<b>PROJECT REPORT COVER SHEET</b>	<b>NO. SNCH082-RPT-02</b>
		<b>VERSION 1.0</b>
		Page 1 of 60

Edwin I. Hatch Unit 2 SEISMIC WALKDOWN REPORT, RER SNC425082

Resolution of Fukushima Near-Term Task Force Recommendation 2.3: Seismic

Figure 4 –Empty Holes on Panel Front (2R42-S026)

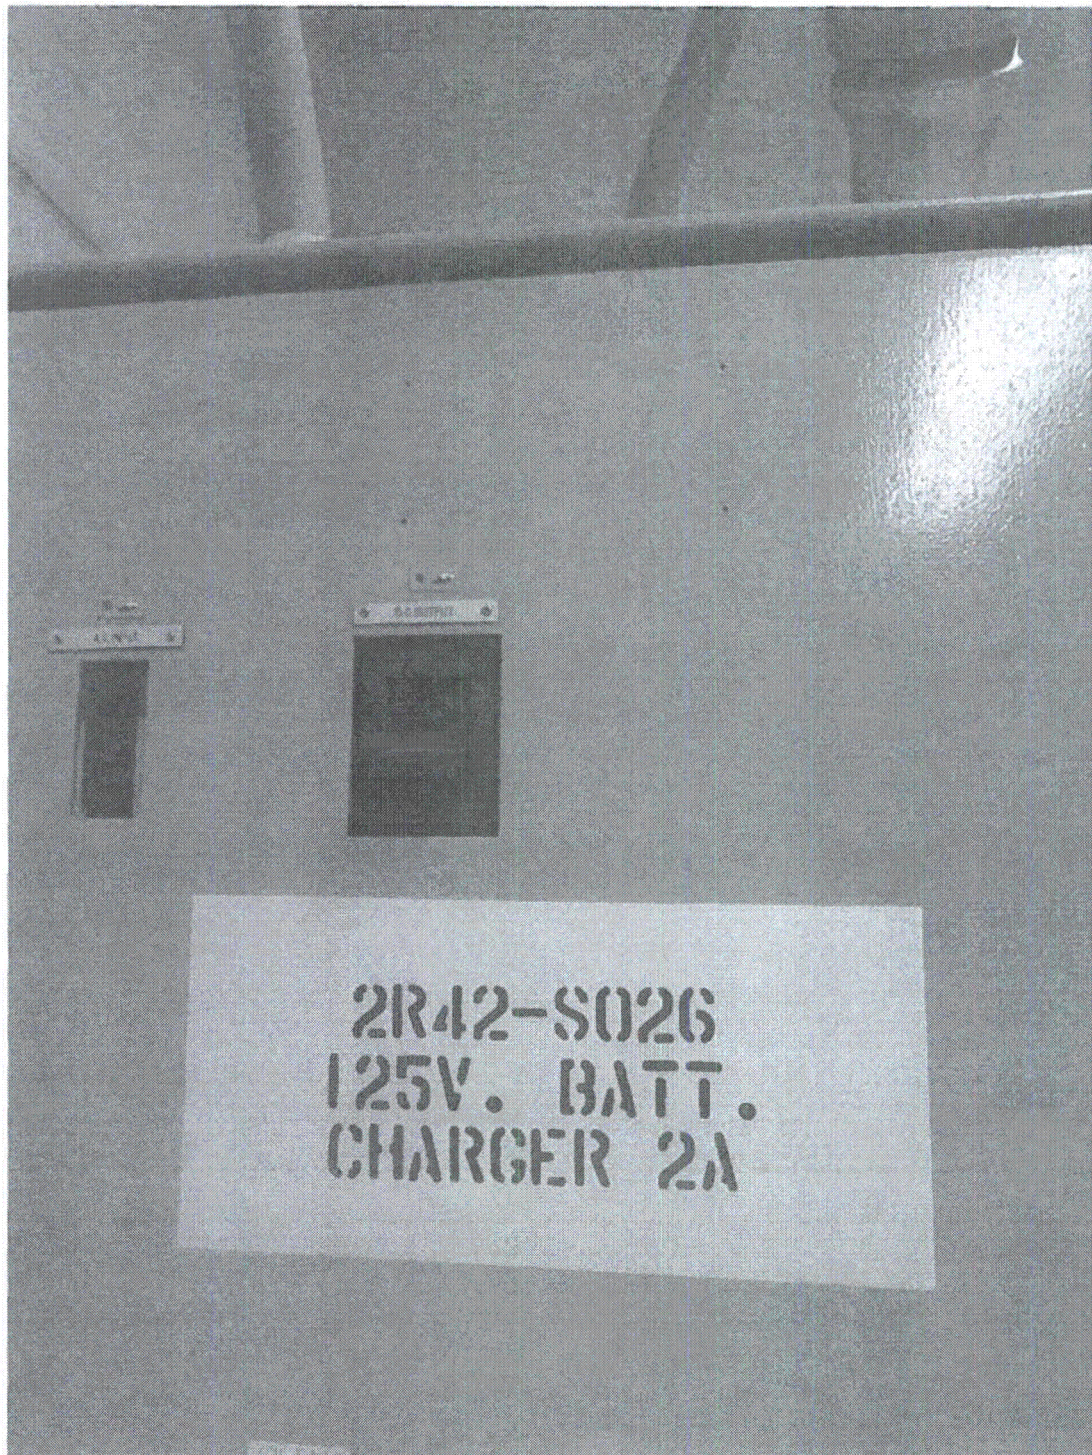
*There are four holes on the front of the battery charger without screws. The holes are for an internal attachment or grounding configuration that is not being utilized, so there are no screws missing. Therefore, there is no potentially adverse seismic condition.*

Figure 3 – Gap Between Unistrut and Wall (2R42-S052)

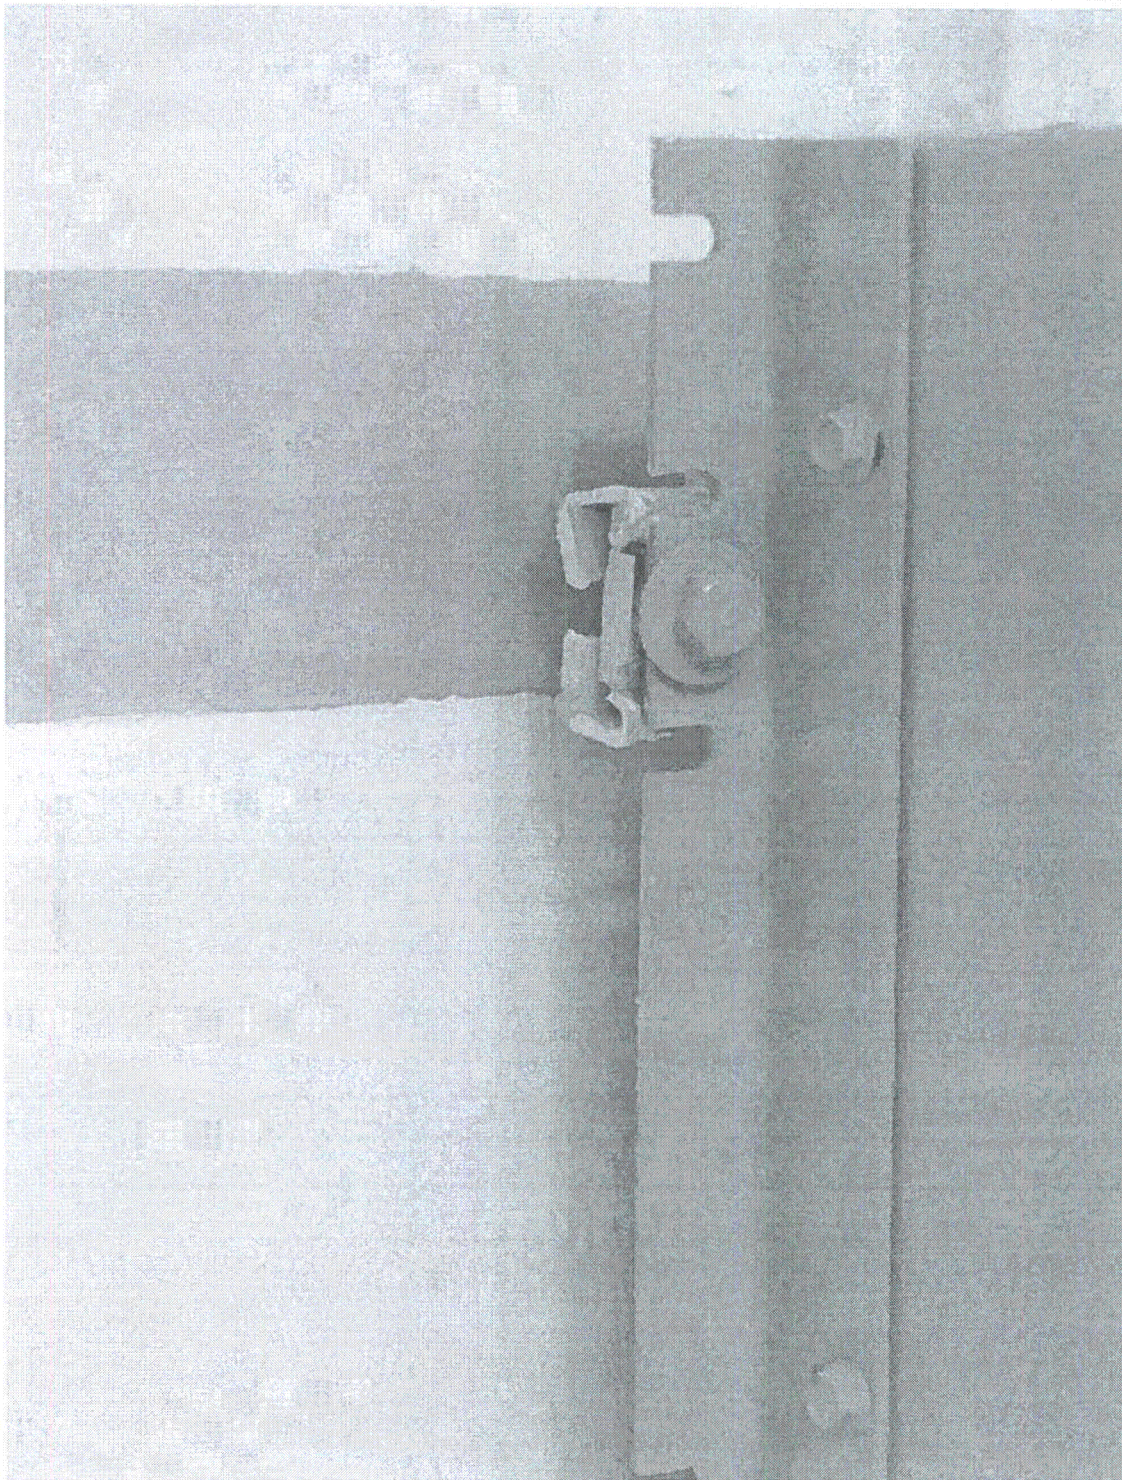
*The Unistrut member supporting the battery charger is bent out from the wall at the far end of the member. The gap between the wall and the member is less than 1/4", so the gap is not significant. In addition, the bolt attaching the charger to the unistrut channel at that location appeared to be over tightened to the point that the unistrut is sprung and the lower edge of spring nut no longer makes proper contact with the inner edge of the unistrut channel (See Figure 3). This condition reduces the connection's strength compared to a properly installed spring nut connection. The current battery charger is supported by 3 additional unistrut bolts and a vertical conduit which also provides additional support to the battery charger in the vertical direction. However CR 520297 has been generated to correct this condition.*

Figure 4 – Interior of the panel (2R42-S052)

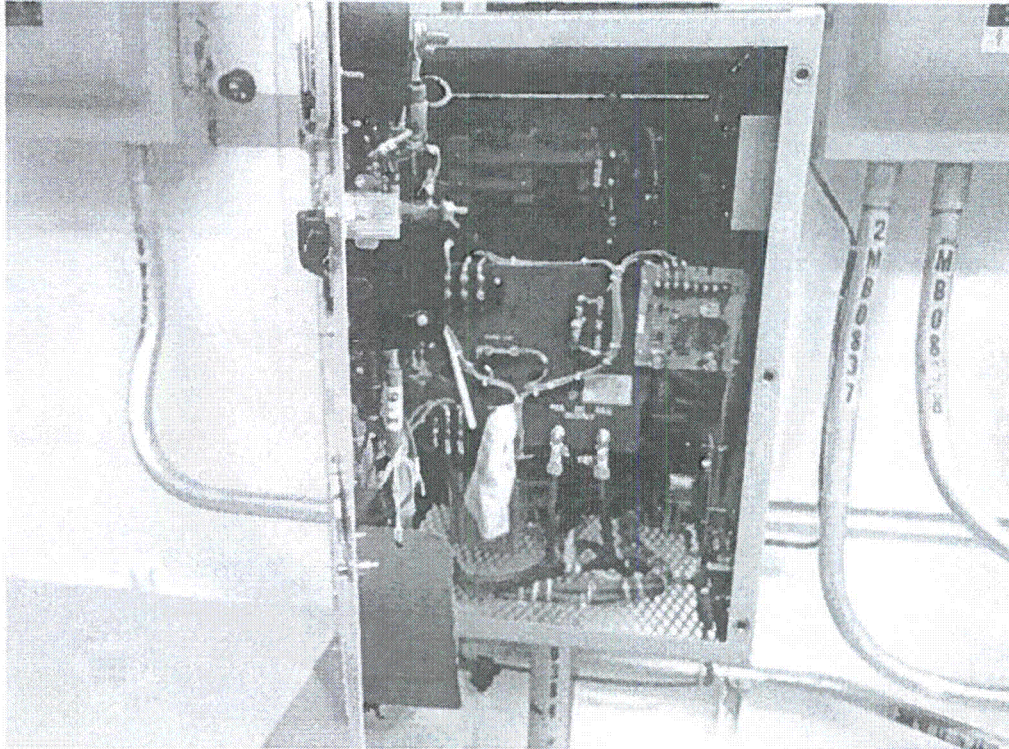
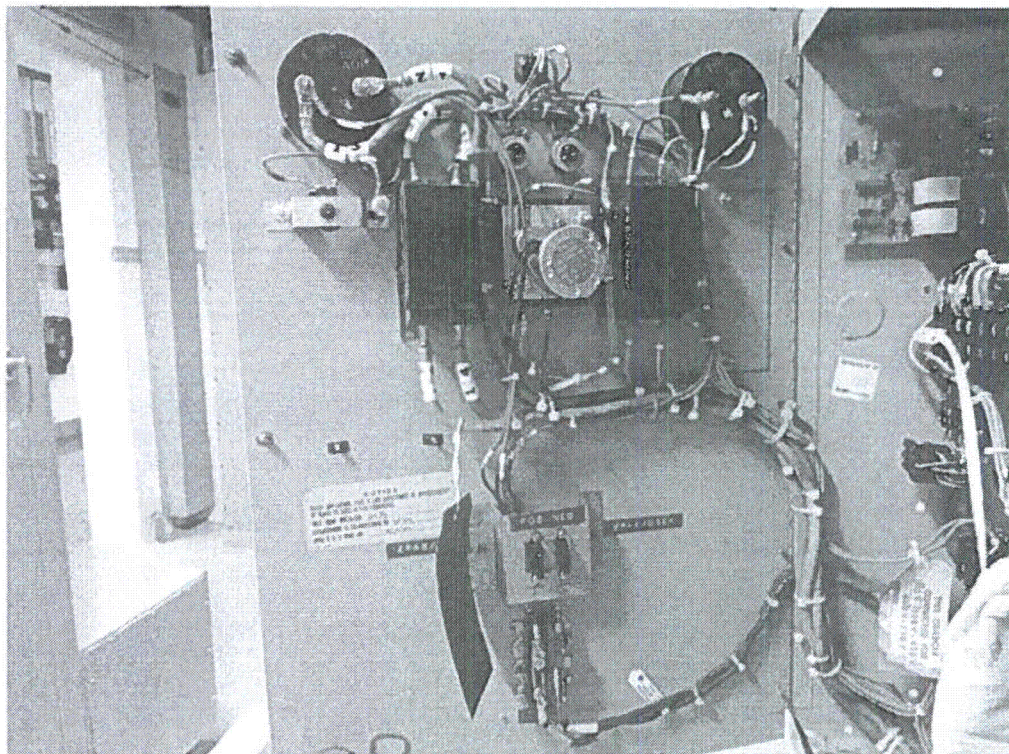
*Components inside the panel were inspected visually in accordance with the direction provided in the FAQ related to opening panels. The panel was opened under WO# SNC436331. No potentially adverse seismic conditions were found.*
